**Re: PCD File No. PPR2329  
The Rock Commerce Center, 2nd Review  
Response to Comments**

Please accept this letter on behalf of Central Development, LLC, the applicant for The Rock Commerce Center. We received your comment letter dated December 8, 2023, regarding the application and we offer the following responses:

**THE ROCK COMMERCE CENTER**  
**GRADING AND EROSION CONTROL PLANS**  
 FINAL EROSION CONTROL PLAN

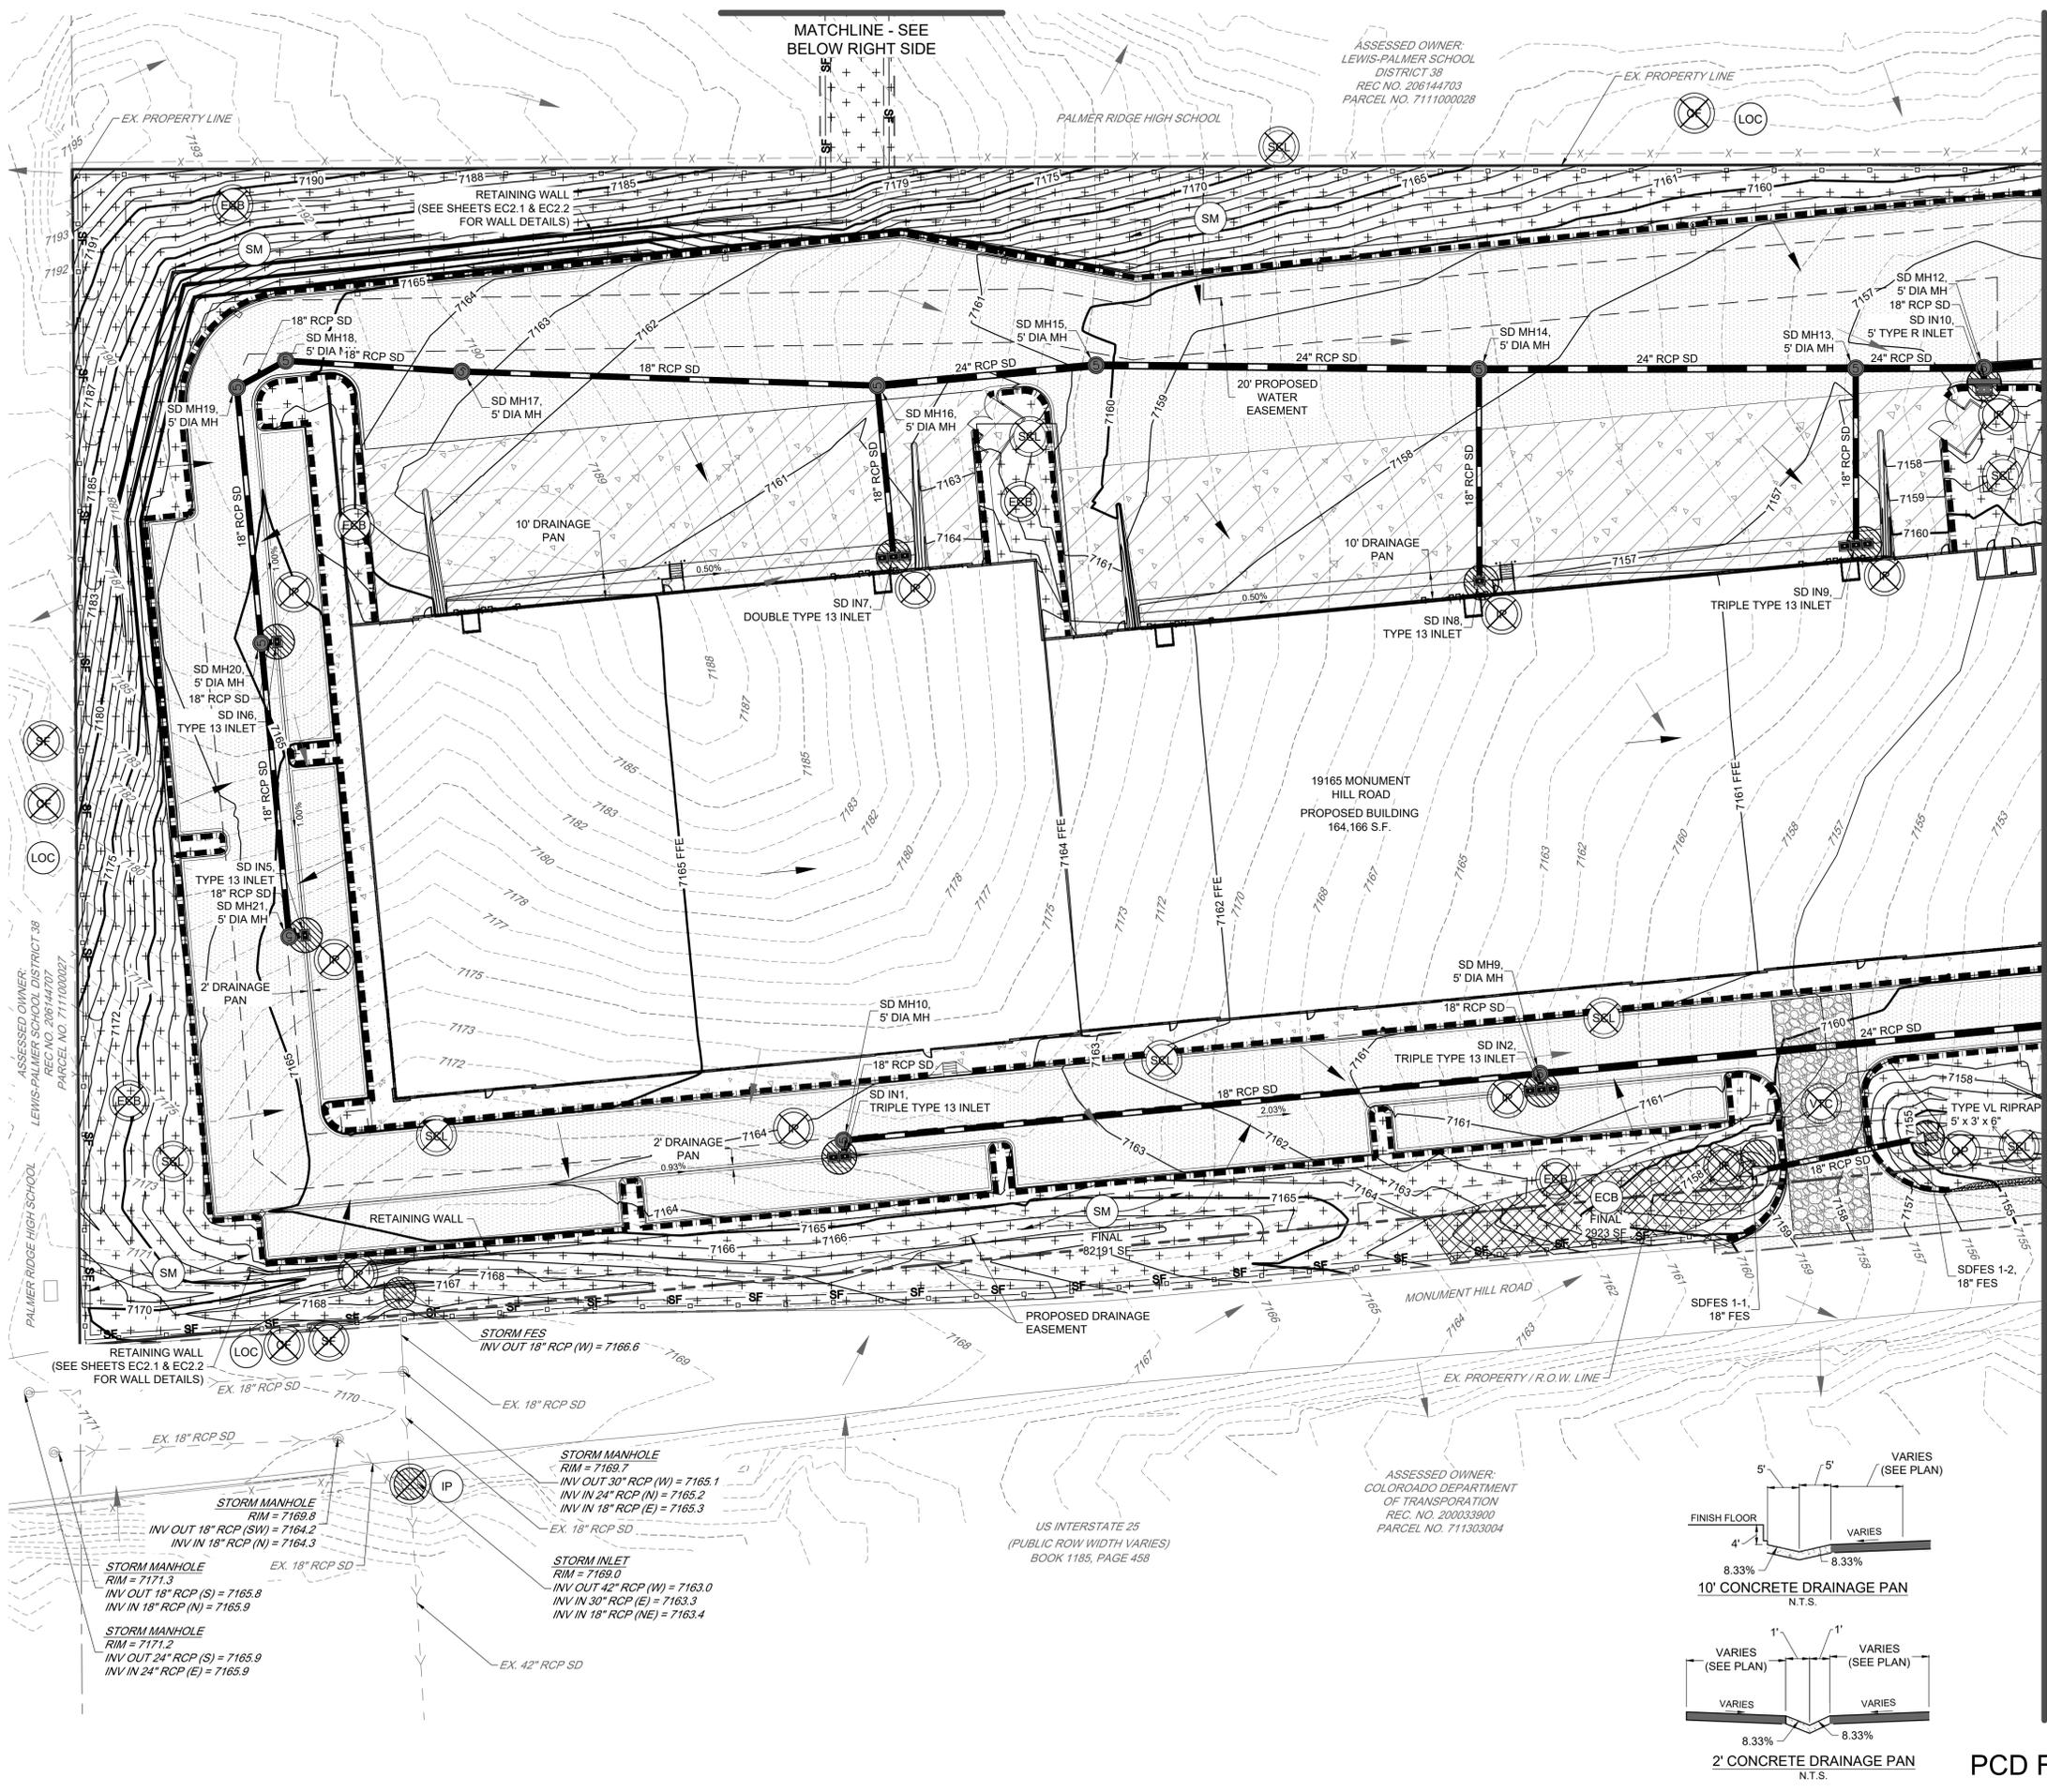
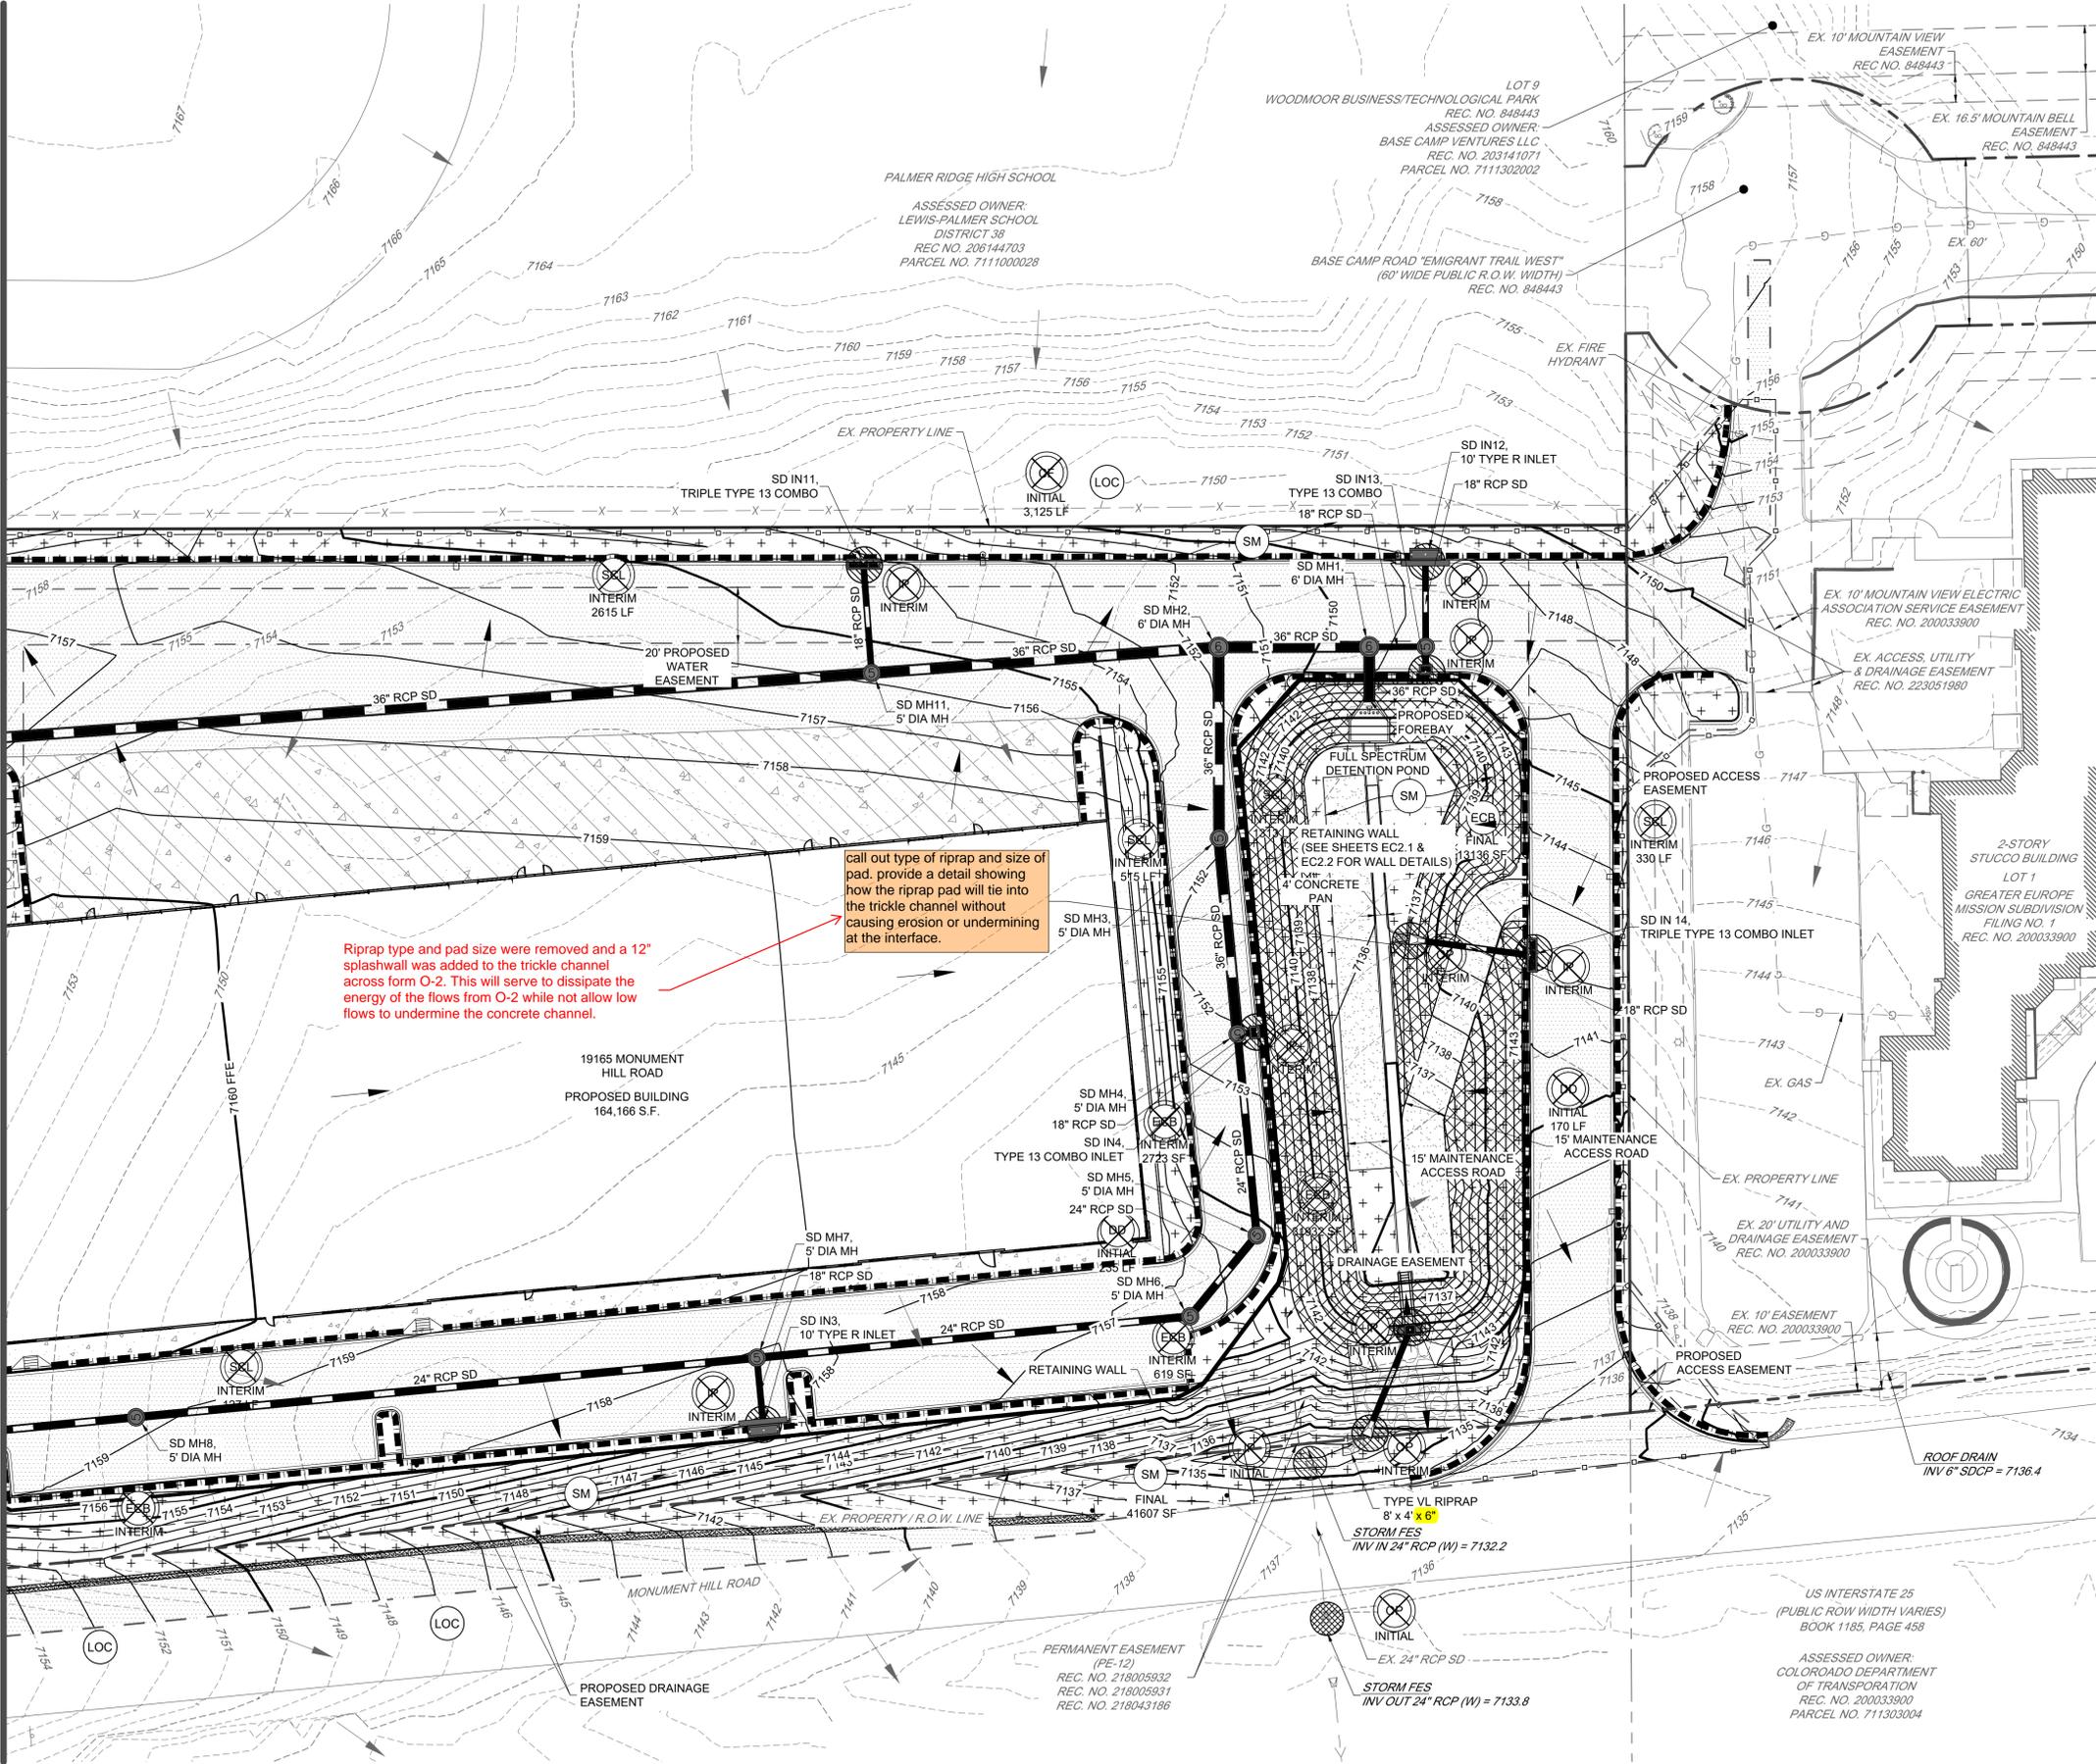
9. Call out type of riprap and size of pad. Provide a detail showing how the riprap will tie into the trickle channel without causing erosion or undermining at interface.

**Response:** The trickle channel was extended up to the flared end section and a splash wall was added where this trickle channel branch meets up with the main trickle channel to act as a energy dissipator as the flow is directed 90 degrees towards the outlet structure.
